REZ2023-00024, WESTHAVEN PROPERTIES, L.L.C., ET AL.

Commercial and Residential Rezoning Report
Cold Harbor Magisterial District
Board Meeting Date: September 25, 2024

Executive Summary

Planning Analysis

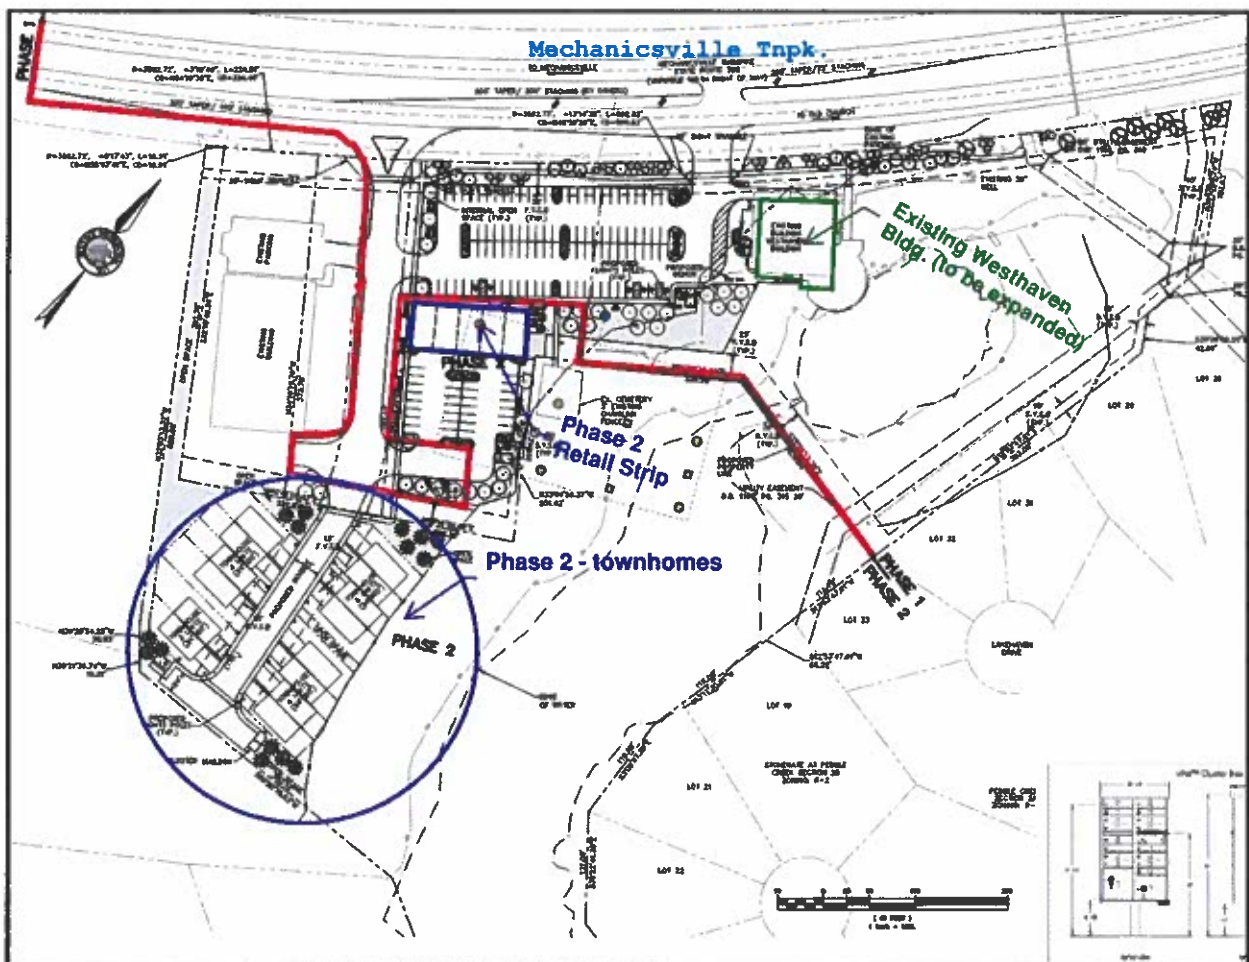
A total of 0.4 acres of qualified open space is provided, most of which is accessible. The plan shows four small open spaces at the end of each row of townhomes, which are accessible to the townhome units. However, some areas being counted to meet minimum open space requirements seem unusable for recreation purposes, including a narrow strip of land between two townhome structures and a narrow strip that extends alongside a commercial structure without any pedestrian path. Because of the location of these open space areas, they will likely become unusable space that requires maintenance by the HOA.

Most agency comments have been addressed with the applicant's resubmittals or are features that must be addressed during the site plan and subdivision review processes. However, Public Works comments have not been fully addressed. No detention basins are shown on the plan, and Public Works has indicated that stormwater regulations will likely require on-site detention; there is concern that the plan layout does not provide space to accommodate a detention basin if one is deemed necessary.

Elevations - Phases 1 and 2

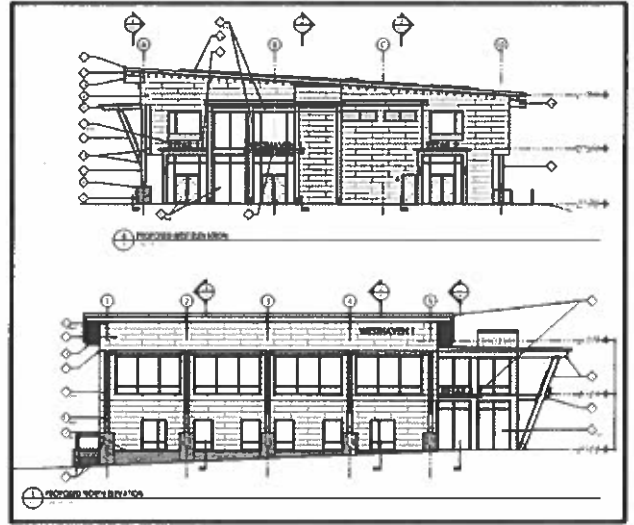
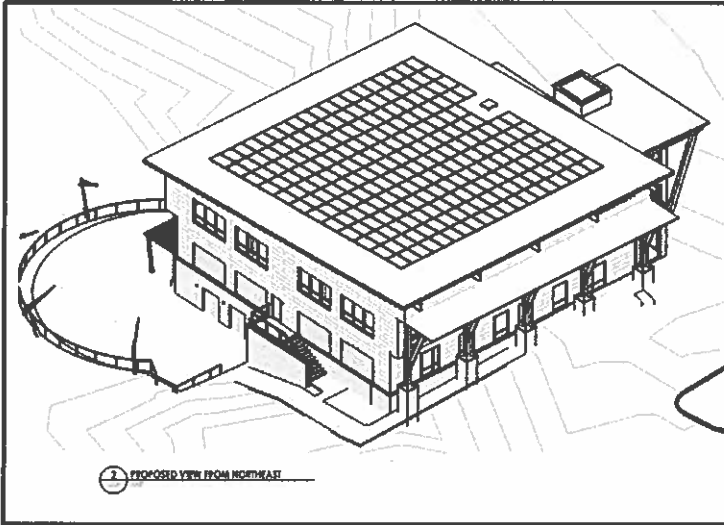
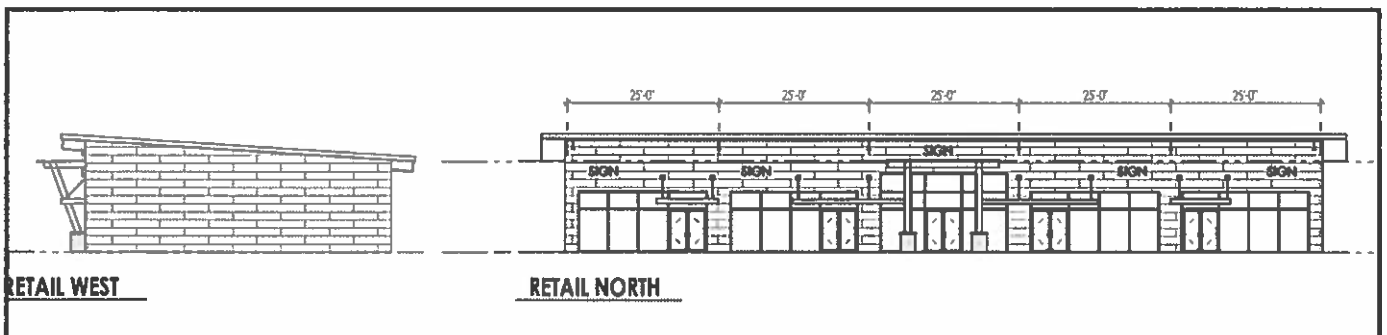
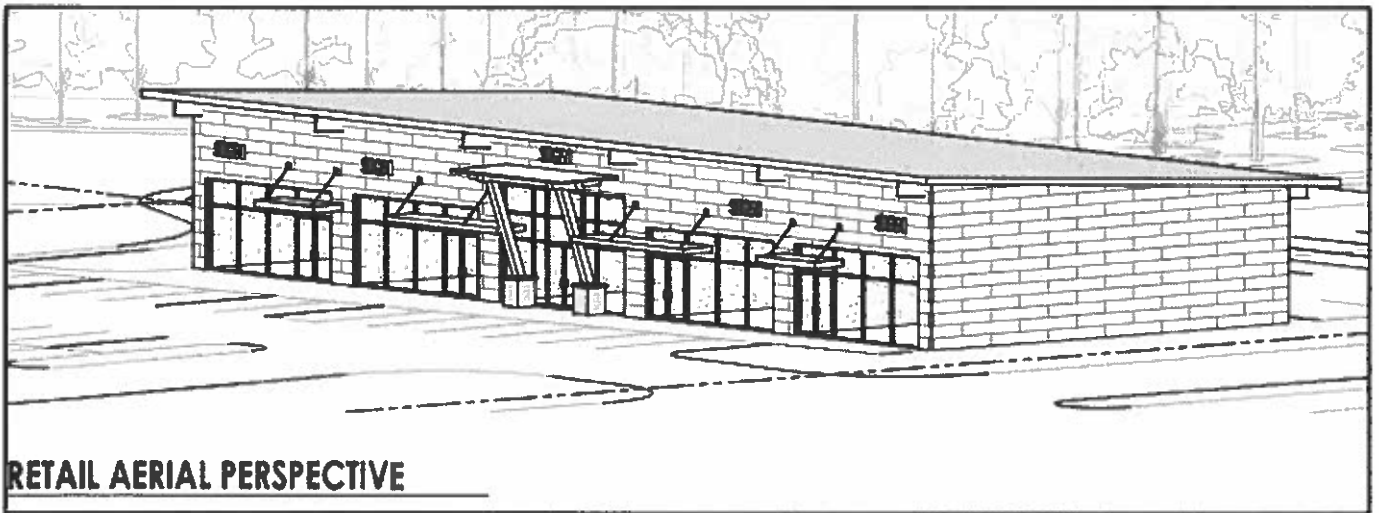
The elevations show that the character of the existing Westhaven Lake building will be greatly changed with an additional floor and windows. Architectural wood timber beam columns and pergola-styled support features for overhang roofing over outside areas will be added to building facades. Other materials being used to change the character of this building include stone veneer siding, fiber-cement paneling, aluminum storefront windows, and seamed metal roofing systems. Solar panels are also planned on the roof. See Sheets A3.1, A3.2 and CS.04 of the attached plans.

The retail strip center with five possible units is shown on Sheet A8. The materials used for the Westhaven Lake building are duplicated on this structure, which is otherwise the shape of a typical strip center. Consistent materials, architectural features, and styling help create a unified development.
